15.7 Radioactive Release from Subsystems and Components

The information in this section of the reference ABWR DCD, including all subsections, figures and tables, is incorporated by reference with the following departure and supplements.

Figure 15.7-2 Offgas System (See Subsection 11.3)

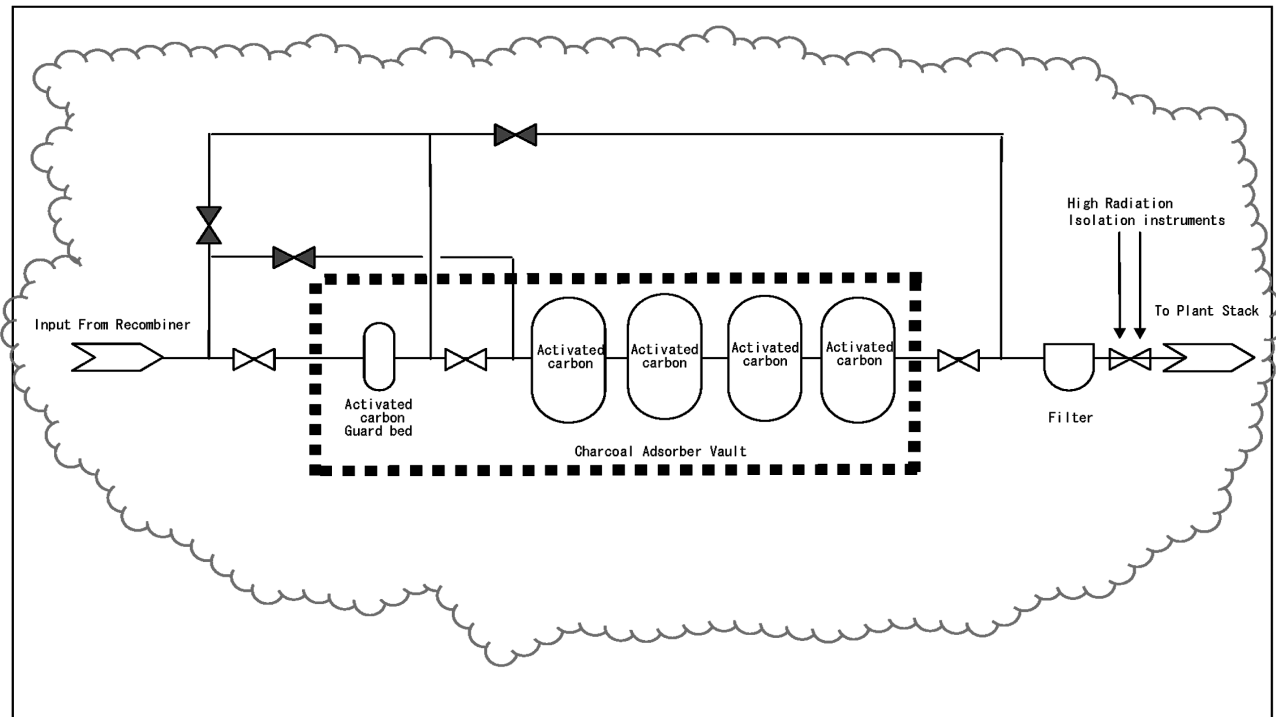
STD DEP 11.3-1 (Figure 15.7-2)

To evaluate the potential radiological consequences of an inadvertent bypass of the charcoal beds, it was assumed that operator error or computer error has led to the bypass of the ~~eight~~four follow-on beds in addition to the failure of the automated air operated downstream isolation valve. It is also assumed that during this period, the plant is running at and continues to run at the maximum permissible offgas rate of 14.8 GBq/s (based upon the assumption of 0.0037 GBq/s/MWt as stipulated in Standard Review Plan 11.3) evaluated to a decay time of 30 minutes from the vessel exit nozzle. Even with the failure of the downstream isolation valve, it is not anticipated or assumed that the isolation instrumentation would fail but would instead

- (1) Flow is through a single 4,721 kg charcoal tank with an evaluated hold up time given by NUREG-0016, equation 1.5.1.6 using K_d 's for Kr and Xe from NUREG-0016.
- (2) ~~An isolation valve prevents flow through the~~ ~~There is no motive force to remove any significant inventory from the eight~~ follow-on charcoal tanks while in bypass and therefore no activity from these tanks is included in the final release calculations.
